BEFORE THE SELWYN DISTRICT COUNCIL

UNDER	the Resource Management Act 1991 (RMA)
IN THE MATTER	of Proposed Private Plan Change 66 to the Operative District Plan: Maddisons Road, Rolleston
BETWEEN	ROLLESTON INDUSTRIAL DEVELOPMENTS LTD Applicant
AND	SELWYN DISTRICT COUNCIL

**STATEMENT OF EVIDENCE OF NICHOLAS DAVID ROBERT GRIFFITHS ON
BEHALF OF THE CANTERBURY REGIONAL COUNCIL**
30 July 2021

Figure 1. Stream channel long section and modelled 500 year ARI water level profile.

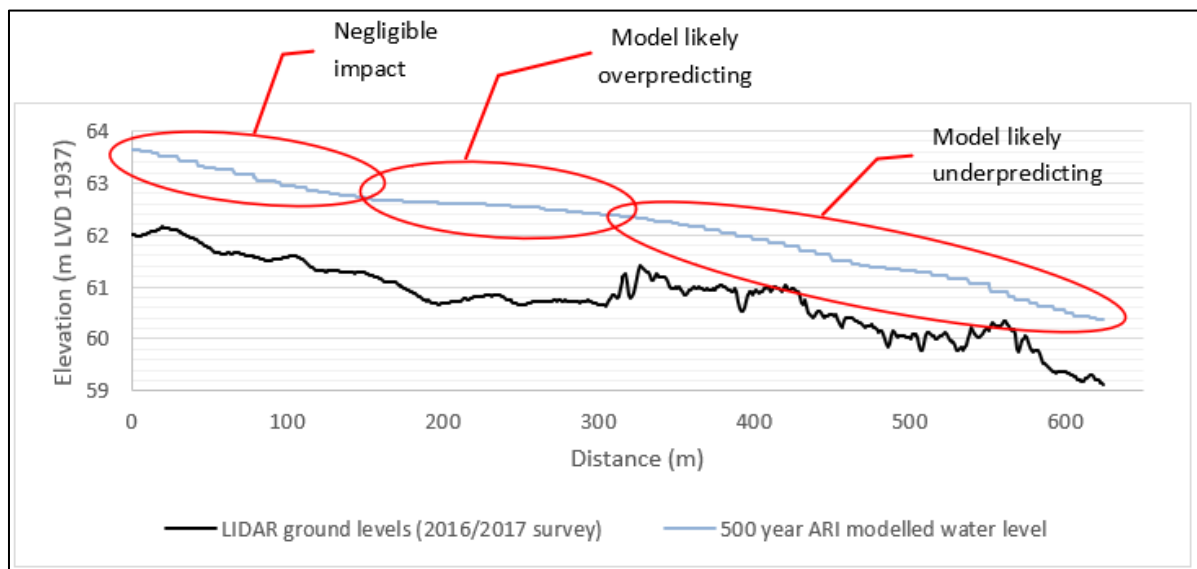
- 12.1 The LIDAR inaccuracies will have negligible impact on modelled flood depths within the upper ~ 150 m of the channel. This is because the invert levels through this part of the channel are higher, or at a similar level to the 'crop barrier' levels further downstream.

12.2 The LiDAR inaccuracies are likely to have elevated modelled water depths in the part of the channel from ~ 150 m downstream through to the 'crop barrier' at ~ 300 m downstream. Water depths here may have been elevated by up to 0.6 m, as this is the approximate height of the 'crop barrier' that acts to block the channel in the model terrain. Peak modelled water depths through this part of the channel range from around 1.6 m to 1.9 m and at least some areas would therefore still meet the high hazard area definition in the absence of the LiDAR inaccuracies.

12.3 The LiDAR inaccuracies will have likely resulted in the underestimation of flood depths in the southern part of the channel that runs through the crop affected area. This is because some water that would have otherwise flowed through this part of the channel has ponded behind the crop barrier and been diverted away toward the north-east. High hazard areas through this part of the channel would therefore be no less extensive (but possibly more extensive) than shown in the model results in the absence of the LiDAR inaccuracies.

13 Figure 1 below shows a long section of the stream channel invert derived from the LiDAR data, and corresponding modelled 500 year ARI water level profile. This also includes annotation to highlight the points described above.

Figure 2. Map showing the LiDAR 1 x 1 m digital elevation model, modelled hazard values, stream channel long section, and distance markers.

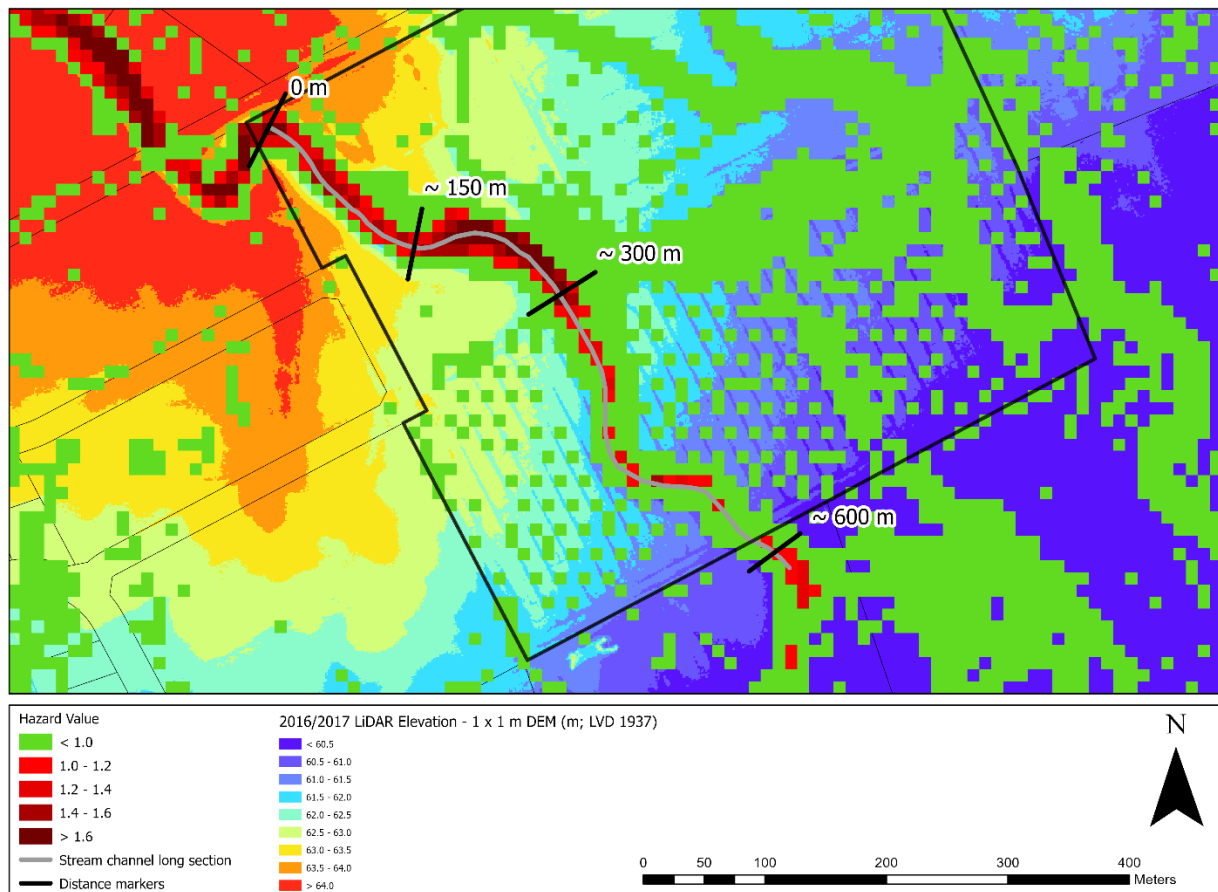
- 14 Figure 2 below shows the 1 x 1 m LiDAR digital elevation model, overlain with the modelled 500 year ARI hazard values (equal to water depths). The figure also shows the location of the stream channel long section (presented in Figure 1) and distance locations described above.
